Access Compliance Report

Public Rights-of-Way

(Pedestrian Signals)

Intersection ID: N/A	Main Street:	Cross Street: N/A	Location: N/A
ADA ID: 3957ADA5E254	Signal Type: One Push Button-APS	Overall Compliance: No	Severity Score: BTN 1: N/A BTN 2: N/A No BTN: N/A
Codes/Mitigation Info/Possible Solution		Field Measurements/Component Compliance

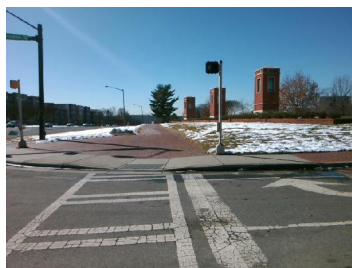
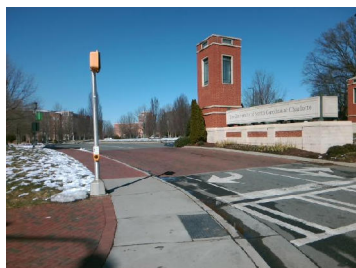
Compliance	Description	Data	Compliance	Description	Data
	Button Count	Button1	Yes	Distant to Additional Button (in)	488.0
	Additional Button Present?	Yes		Additional Button ID	BFCC7F00701F
N/A	Signal Buttons Required?	N/A	N/A	Additional Ped Posts Required	N/A
	How Many Ped Street Xings?	N/A		Located In An Island/Median?	N/A
N/A	B 1 Sign Present?	Yes	N/A	B 2 Sign Present?	N/A
Yes	B 1 Sign Purpose?	Yes	N/A	B 2 Sign Purpose?	N/A
Yes	B 1 Sign Lettering & Contrast?	Yes	N/A	B 2 Sign Lettering & Contrast?	N/A
Yes	B 1 Parallel To XWalk?	Yes	N/A	B 2 Parallel To XWalk?	N/A
Yes	B 1 PAR to Button?	Yes	N/A	B 2 PAR to Button?	N/A
Yes	B 1 PAR to XWalk?	Yes	N/A	B 2 PAR to XWalk?	N/A
Yes	B 1 Clear Floor Space?	Yes	N/A	B 2 Clear Floor Space?	N/A
N/A	B 1 FWD Approach?	Yes	N/A	B 2 FWD Approach?	N/A
N/A	B 1 FWD Approach Constrained?	Yes	N/A	B 2 FWD Approach Constrained?	N/A
No	B 1 FWD Approach Reach (in)	5.0	N/A	B 2 FWD Approach Reach (in)	N/A

Yes	B 1 FWD Approach Width (in)	48.0	N/A	B 2 FWD Approach Width (in)	N/A
N/A	B 1 FWD Approach Obstruction?	Yes	N/A	B 2 FWD Approach Obstruction?	N/A
N/A	B 1 FWD Approach Obstruction Dist (in)	2.0	N/A	B 2 FWD Approach ObstructionDist (in)	N/A
N/A	B 1 PARA Approach?	Yes	N/A	B 2 PARA Approach?	N/A
N/A	B 1 PARA Approach Constrained?	Yes	N/A	B 2 PARA Approach Constrained?	N/A
Yes	B 1 PARA Approach Reach (in)	5.0	N/A	B 2 PARA Approach Reach (in)	N/A
No	B 1 PARA Approach Width (in)	48.0	N/A	B 2 PARA Approach Width (in)	N/A
N/A	B 1 PARA Approach Obstruction?	Yes	N/A	B 2 PARA Approach Obstruction?	N/A
N/A	B 1 PARA Approach Obstruction Dist (in)	2.0	N/A	B 2 PARA Approach ObstructionDist (in)	N/A
Yes	B 1 Clear Floor Space Slope (%)	1.6	N/A	B 2 Clear Floor Space Slope (%)	N/A
No	B 1 Clear Floor Space XSlope (%)	6.1	N/A	B 2 Clear Floor Space XSlope (%)	N/A
N/A	B 1 PAR Slope (%)	N/A	N/A	B 2 PAR Slope (%)	N/A
Yes	B 1 Height (in)	37.0	N/A	B 2 Height (in)	N/A

N/A	B 1 Clear Xing Direction?	Yes	N/A	B 2 Clear Xing Direction?	N/A
	B 1 Crossing Direction	To NE		B 2 Crossing Direction	N/A
No	B 1 DistanceTo XWalk (in)	72.0	N/A	B 2 DistanceTo XWalk (in)	N/A
No	B 1 DistanceTo Curb (in)	75.0	N/A	B 2 DistanceTo Curb (in)	N/A
Yes	B 1 Diameter (in)	2.0	N/A	B 2 Diameter (in)	N/A

Possible Solutions: Replace Signal Push Button With APS Button on New Post. Remove & Relocate Sign.
